MILPITAS PLANNING COMMISSION AGENDA REPORT

TITLE: "S" ZONE APPROVAL AMENDMENT NO. SA2007-22

Proposal: A request for various modifications including revised roof elevations, unenclosed stairways, new chimneys stacks, and landscape modifications to a previously approved mixed use development that consist of 93 residential units and approximately 2,633 square feet of commercial retail space

Location: 230 North Main Street (APN 028-24-017 and -018)

Building Elevations

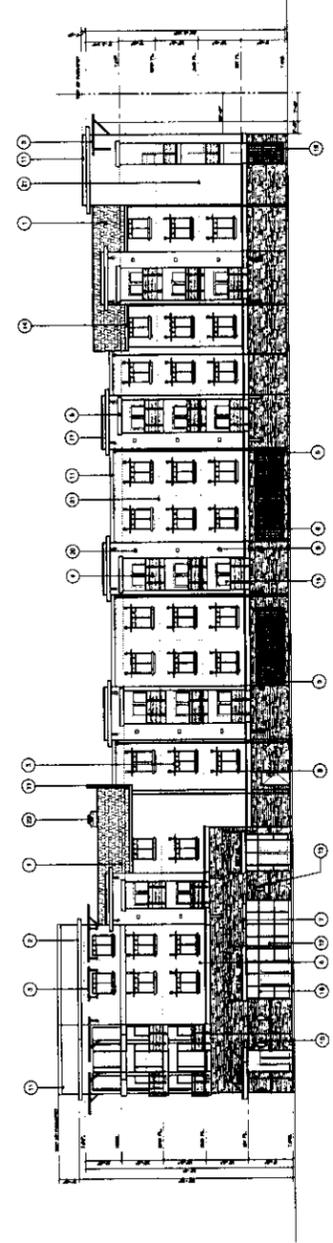
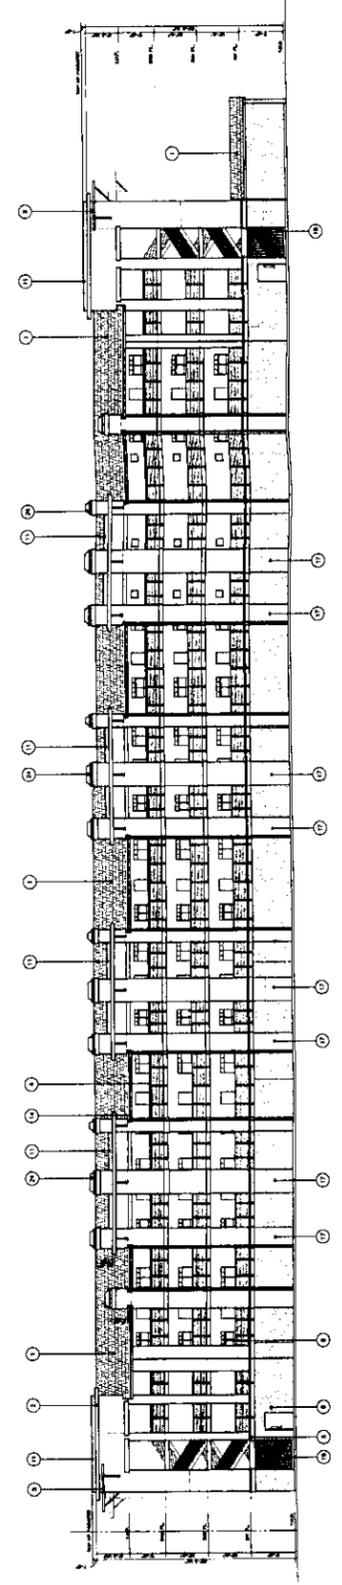
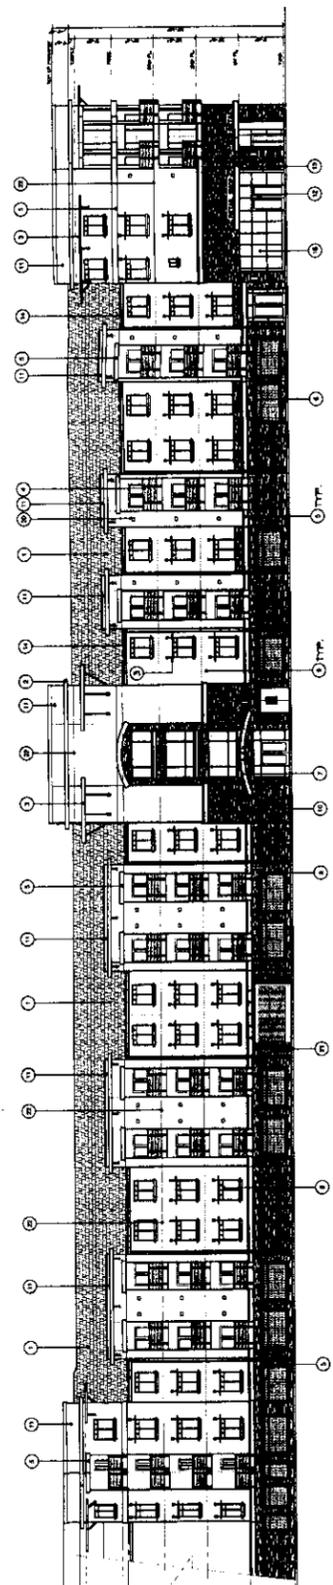
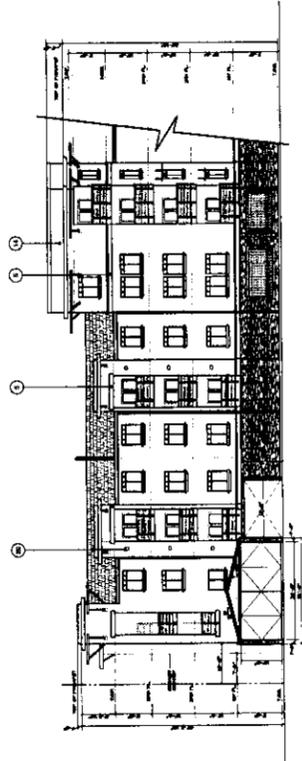
1. Revised roof line on the south elevations – The applicant is proposing to modify the rooflines by changing the hip roof to a gable roof near the tower elements. It also includes a new 30” parapet wall that extends above the roof. This condition also occurs on the north elevation. The modified rooflines on the south elevation are intended to complement the addition of the parapet wall that is required for the 4-hour separation parapet wall. However, the parapet is still visibly higher than the adjacent roof ridgeline. There is also an exposed vent. To address these concerns, *staff recommends* a condition that the applicant paint and texture the parapet wall on the north and south elevation to

match the roof material. The applicant shall also utilize a lower profile vent for the trash chute vents so that the roof top equipment is not visible. Additionally, the applicant is proposing a slight modification on the pitch of the roof. The pitch is changing from 4 to 12 to 4 ½ to 12-pitch roof. As originally approved, the 4 to 12 pitch would require a stairway access to the roof, which cannot be designed without significant change to the building. The increased pitch would not change the overall design or increase the overall height of the building.

2. Unenclosed stairways located at the northeast and southeast corner towers – The applicant is proposing to remove the row of windows on each stairway tower (Stairways 2 and 3) and have unenclosed stairways to meet Building Code exiting requirements. The towers are located at the rear of the project and will not detract from the treatment on the other towers. The applicant has added new decorative metal security screens to prevent trespassing into the building. *Staff recommends* as a condition of approval, decorative scoring to be added on the southeast and northeast towers to be consistent with the treatment on the other three towers located at the northwest, west, and southwest corner elevations.

3. Removal of garage vents and installation of new chimney exhaust for the mechanical ventilation of the garage structure on the east elevation – The applicant is removing the vents and will be incorporating new mechanical venting. The new chimney exhaust stacks will be located on the south elevation (rear of the project). Staff is concerned with the visual appearance of the chimneystacks. As proposed, the chimneystacks are not consistently sized throughout. As a result, staff recommends as a condition that the chimney exhaust stacks are equal in size and height. Furthermore, the applicant is replacing the intermittent solid rails with open rails. The removal of the solid rails would create long lineal lines. To improve the aesthetic treatment and articulation of the façade on the south elevation, staff recommends that the applicant maintain the solid rails in the four sections where there is a building projection. In staff's opinion, this will help provide architectural relief from the long lineal lines and maintain visual interest. As previously conditioned, the applicant shall add stone veneer to the base of the building.

2. Prior to building permit issuance, the applicant shall paint and texture the parapet wall located at the south and north elevation to match the roof material.

3. The applicant shall utilize a lower profile vent for the proposed trash chute vents shown on the south elevation. (P)
4. Prior to building permit issuance, the applicant shall include decorative scoring on the southeast and northeast towers to be consistent with the treatment on the other three towers located at the west elevation and the northwest and southwest corner elevations. (P)

5. Prior to building permit issuance, the applicant shall redesign the chimney exhaust stacks so that they are equal in size and height. (P)
6. Prior to building permit issuance, the applicant shall maintain solid rails at the four sections where there are a group of three chimney exhausts to provide architectural relief from the lineal lines and maintain good visual interest. (P)
